City of Portland, Maine – Building or Use Permit Application 389 Congress Street, 04101, Tel: (207) 874-8703, FAX: 874-8716

Location of Construction: 4 Alice Court Lot#12 Auburn Pines		Owner: **Ronald J. Dorler Jr.		Phone: **878-8945		Permit No: 000164	
Owner Address: 526 Summit St. Ptld, ME		Lessee/Buyer's Name: N/A		Phone: N/A		Business Name: N/A	
Contractor Name: Liscord & Bartlett, Jeff Bartlett		Address: Not Given		Phone: Not Given		Permit Issued: 8	
Past Use: Vacant		Proposed Use: Single Family Ranch w/attached garage under.		COST OF WORK: \$ 222,000		PERMIT FEE: \$ 1,356	
				FIRE DEPT. <input type="checkbox"/> Approved <input type="checkbox"/> Denied		INSPECTION: Use Group: R3 Type: 5B GOC 499	
Proposed Project Description: Single family dwelling, ranch with attached garage under.				Signature: _____		Signature: <i>Hoffman</i>	
				PEDESTRIAN ACTIVITIES DISTRICT (P.A.D.)		Zone: <i>R-2</i> CBL: 386-AA-012	
				Action: <input type="checkbox"/> Approved <input type="checkbox"/> Approved with Conditions <input type="checkbox"/> Denied		Zoning Approval: <i>OK with conditions 3/7/00</i> Special Zone or Reviews: <i>N/A</i>

BUILDING PERMIT REPORT

CITY OF PORTLAND, ME
BOCA 1996 P

TITLE:
 LIMITED SITE PLAN
 LOT 12, AUBURN PINES SUBDIVISION
 ALICE COURT
 CITY OF PORTLAND
 CUMBERLAND COUNTY

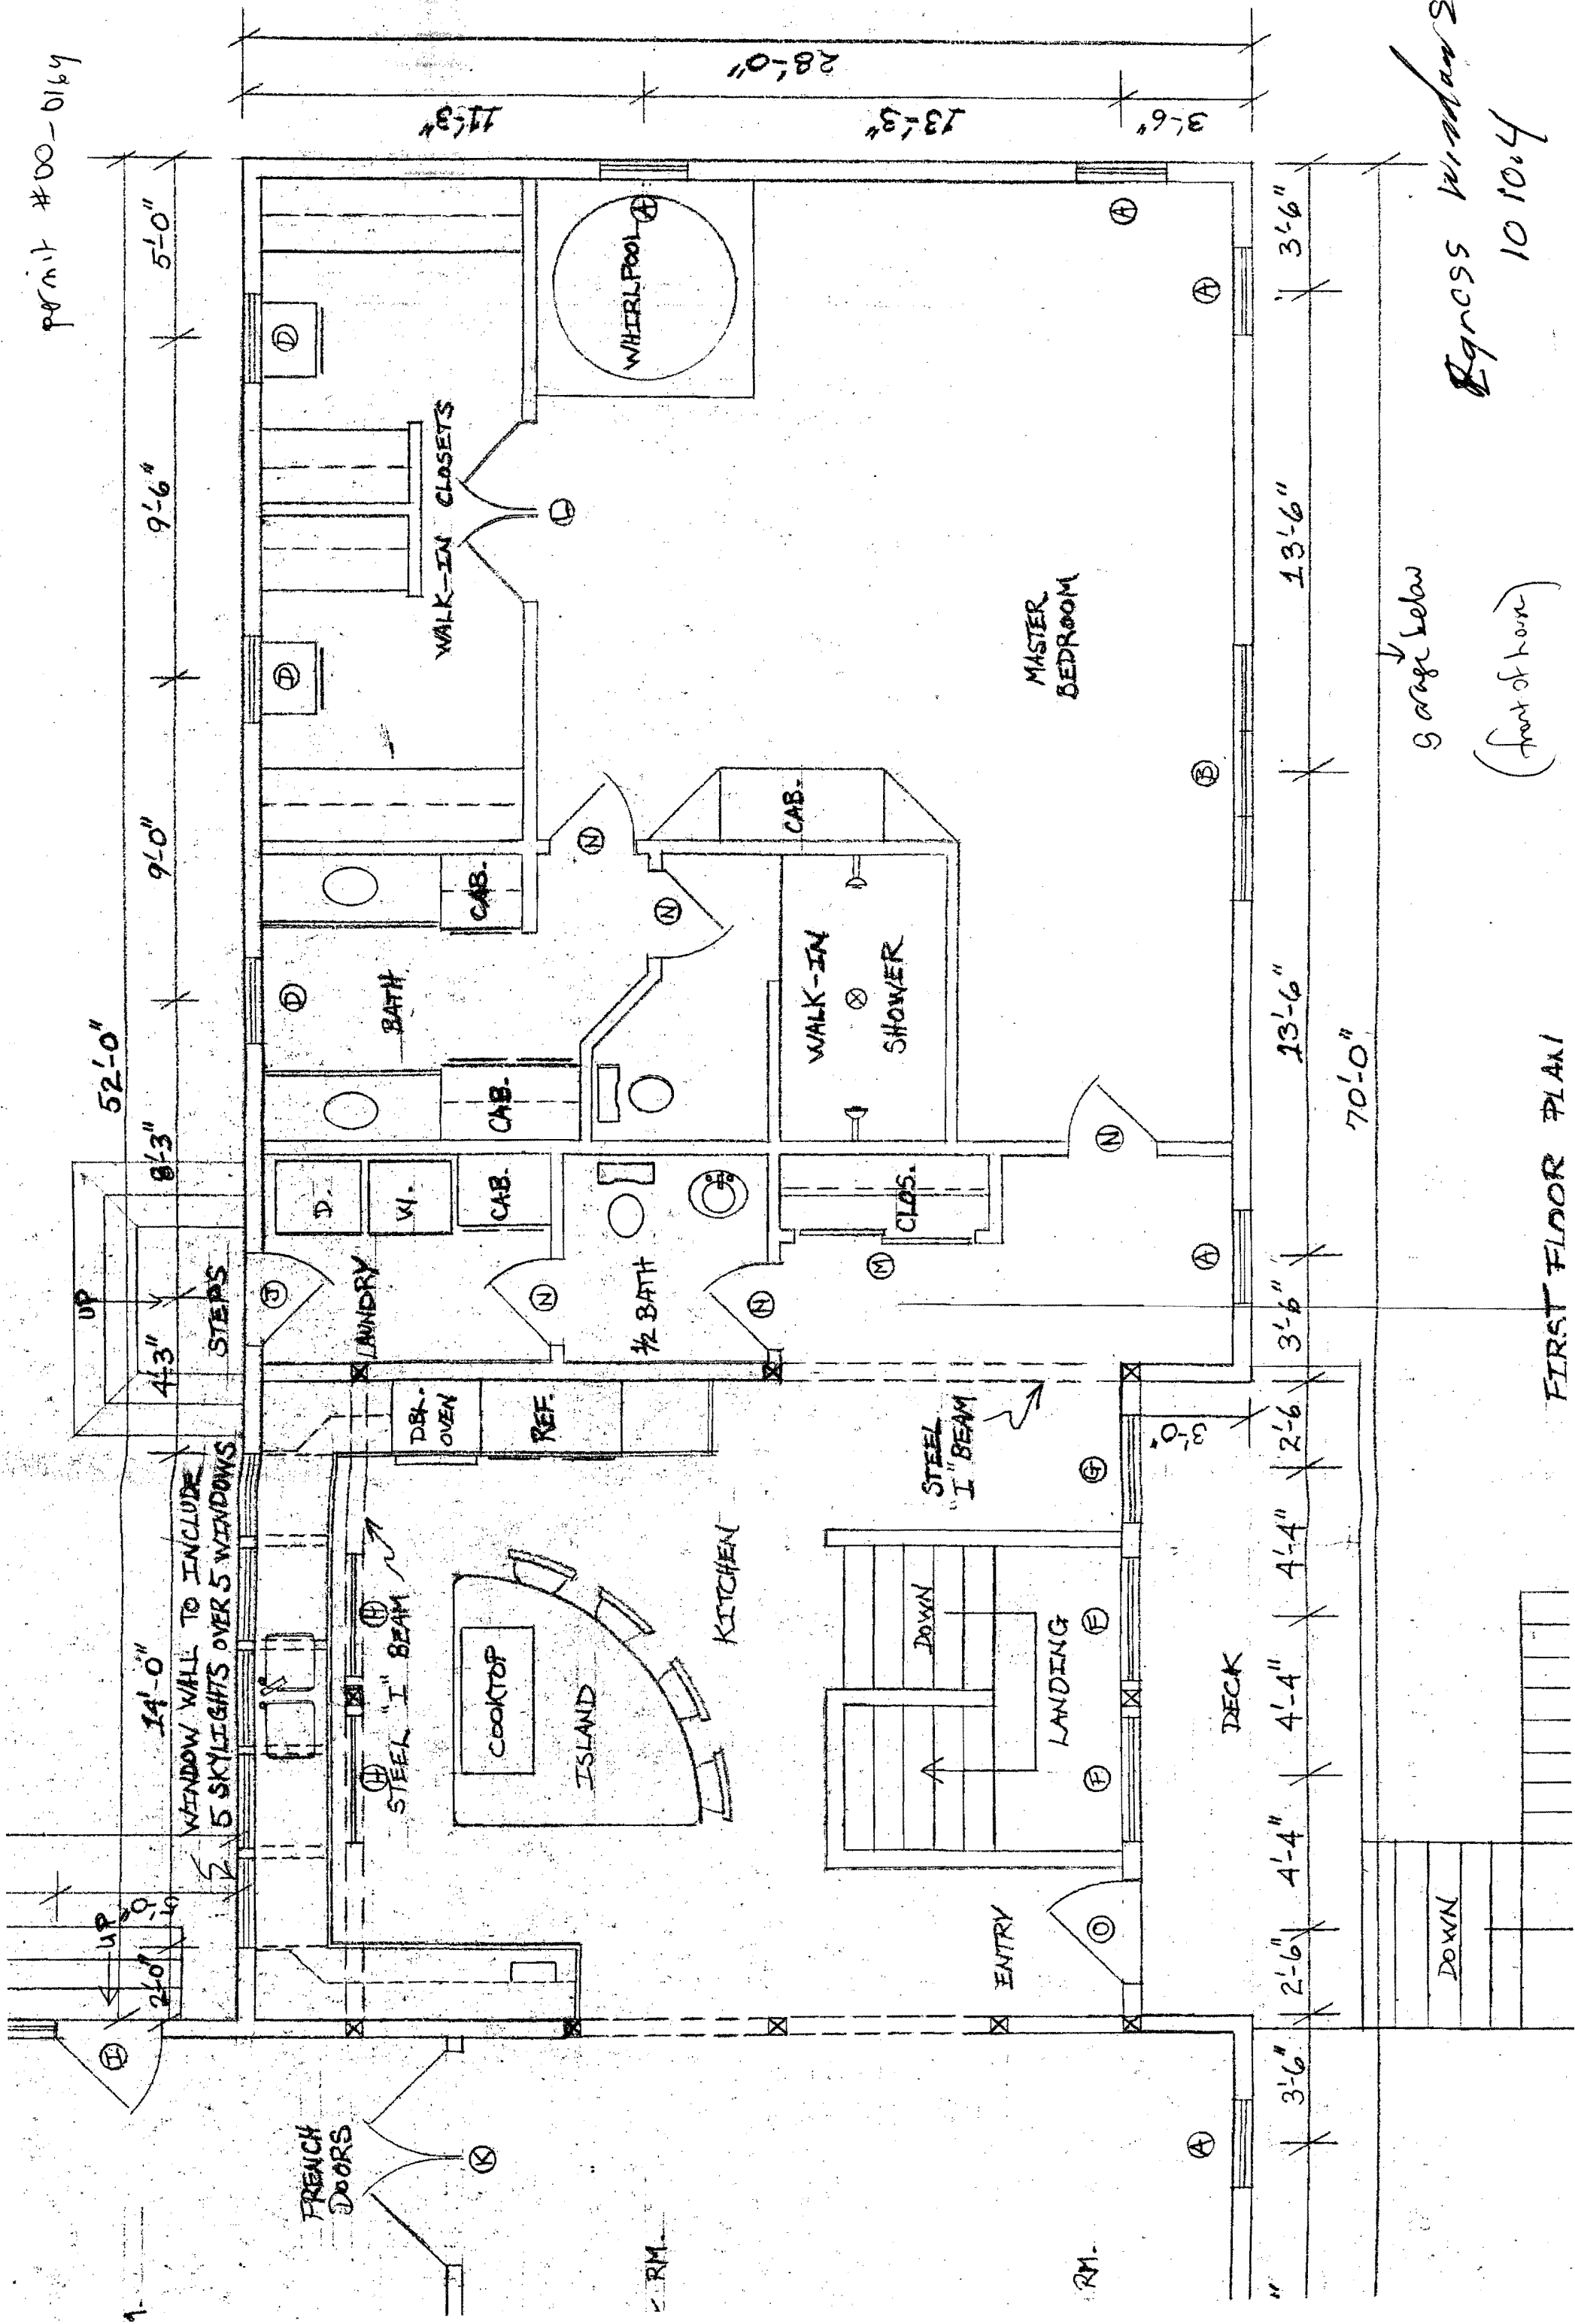
Lot Street Frontage - 50' req \approx 105' shown

Front Yard - 25' req - \approx 90' shown

Rear Yard - 25' req \approx 27' shown

ok
shall not be reduced
on side less than 12'
Side Yard - 2 story 11' req
Projections - 2 rear stairs - front stairs

can reduce 14' to 13' as long as that
1 foot reduction is added to the
other side, or a min of 15' \rightarrow ok
because 26' is shown

Width of Lot - 80' req - 115' shown

Height - 35' max - showing 27' to ridge - ok

20' private easement along left hand side property line
